Proposal for SAS 2.1 Specification to Enable Support for Active Cables

Revision 10

QUELLAN

September 5, 2008

Figure 98 — Mini SAS 4x active cable plug connector that attaches to an enclosure out port

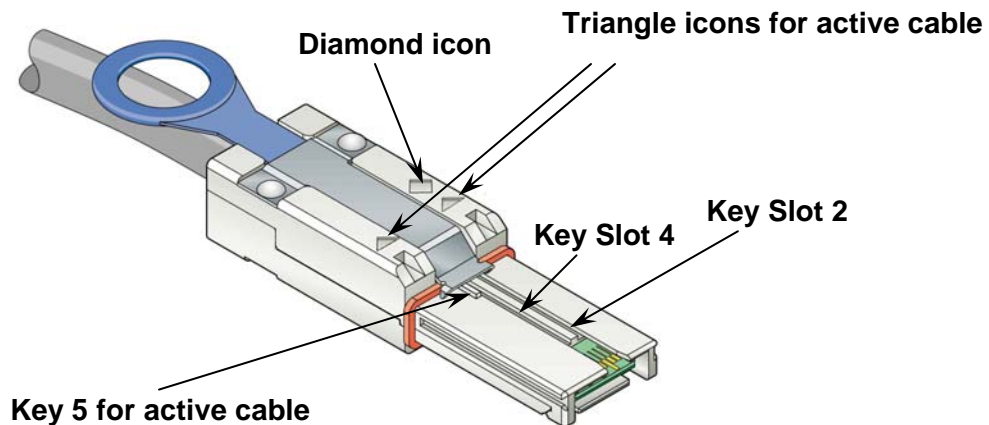
- *Added details of new keying scheme incorporating blocking key in position 5 on the plug and key slots 3 and 5 on receptacle. Updated Figure 98, Table 58 and Table 59 accordingly, added figures 99-101.*
- *Changed the wording in second paragraph of 5.2.7.2.2.1 and second paragraph of 5.2.7.2.2.2 to describe the keying scheme.*
- *Changed the wording of 5.2.7.3.4 from*
“The active cable power supply shall have protection against the connection of the Vcc pin to ground or over-current loading, and shall limit the output current when the supply voltage drops below 2.3 V.”
to
“The active cable power supply shall have protection against the connection of the Vcc pin to ground or over-current loading.”

- *Changed details of active plug keying scheme to differentiate between plugs attaching to enclosure in and enclosure out ports. Updated Figure 98, Table 58 and Table 59 accordingly, added Figure 99, renumbered subsequent figures to be 100-102.*

In order to ensure that active cables are not intermateable with passive receptacles, differentiating keying shall be provided by having key slots in positions 2, 4 and 6 and a blocking key in position 5 on the plug connector, and key slots in positions 3 and 5 on the receptacle connector in addition to keys 2, 4 or 6 used identify a receptacle for an enclosure out, in or universal port. In addition, two triangle icons on each side on the plug connector shall be added to the plug connector to identify an active cable assembly. The plug connector key positions and icons are summarized in Table 58.

Figure 98 shows an active mini SAS 4x cable plug connector that attaches to an enclosure out or universal port:

Figure 99 — Mini SAS 4x active receptacle connector - end device or enclosure universal port

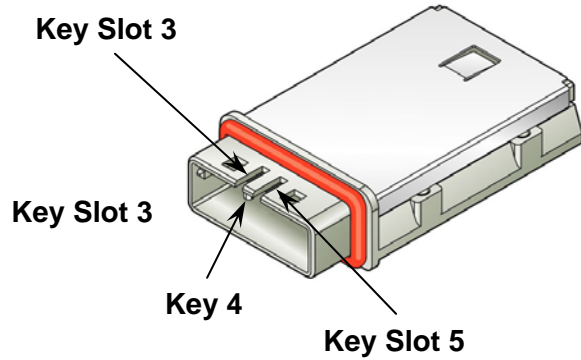
In order to ensure that active cables are not intermateable with passive receptacles, differentiating keying shall be provided by having key slots in positions 2, 4 and 6 and a blocking key in position 5 on the plug connector, and key slots in positions 3 and 5 on the receptacle connector in addition to keys 2, 4 or 6 used identify a receptacle for an enclosure out, in or universal port. In addition, two triangle icons on each side on the plug connector shall be added to the plug connector to identify an active cable assembly. The plug connector key positions and icons are summarized in Table 58.

Figure 100 shows an active Mini SAS 4x receptacle connector used by end devices or an enclosure universal port.

Figure M.1 — Dual comparator design for active cable detection

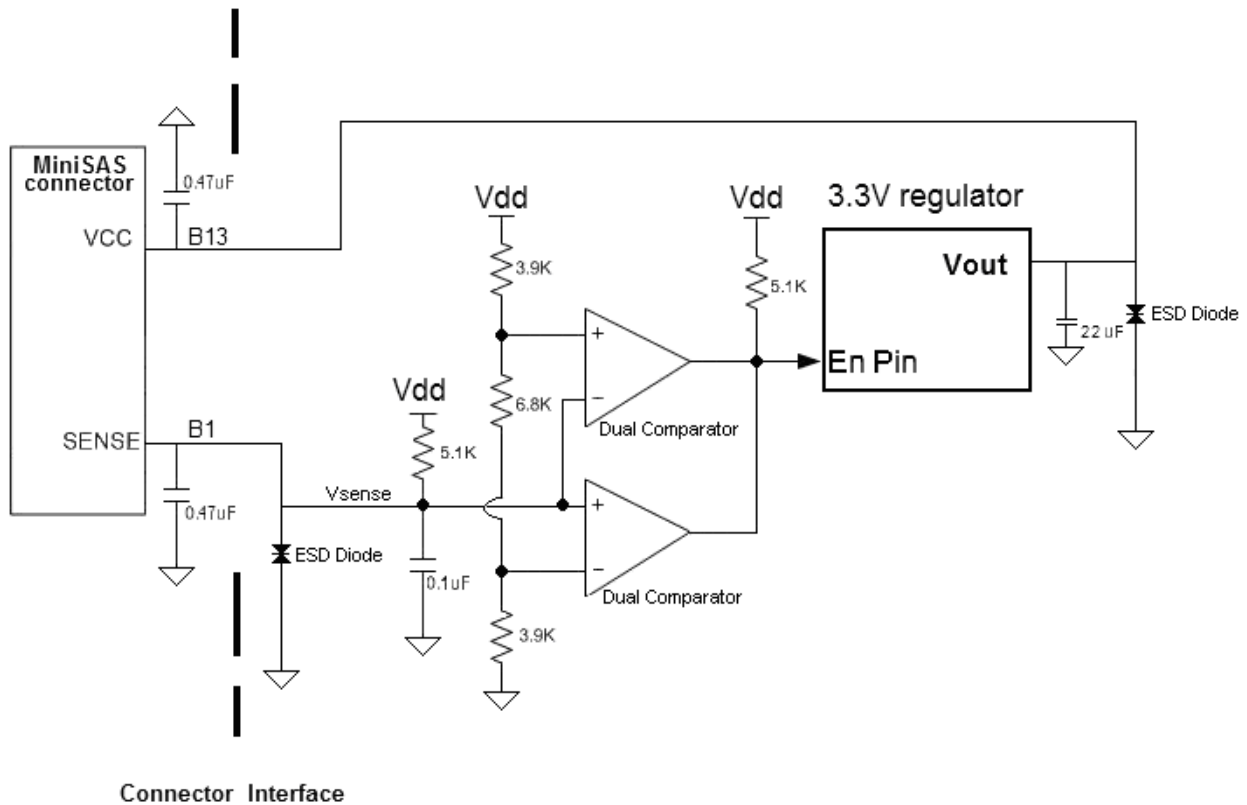
- *Edited most of the wording throughout the document to conform to the T10 style guide and to incorporate comments received from the group*
- *Deleted the minimum value for Supply Current in Table 61 and changed the maximum value from 600 mA to 319.4 mA.*
- *Edited the Informative Annex M to conform to the T10 style guide, dropped Table M.1 (parts List) and edited Figure M.1 to identify the function of the components.*

- *Title and other references to the specification is now 2.1 instead of 2.x*
- *The pinout of active mini SAS cables has been changed in Table 60: the Sense pin is now B1 instead of B10, and pin B10 reverts to ground. The change is also reflected in Figure M.1 of Annex M.*

Fig M1 is an example design utilizing a dual comparator to determine from the sense pin on the active cable plug if an active cable is in operation. The circuit then supplies power based upon whether there is an active cable connected to the receptacle.
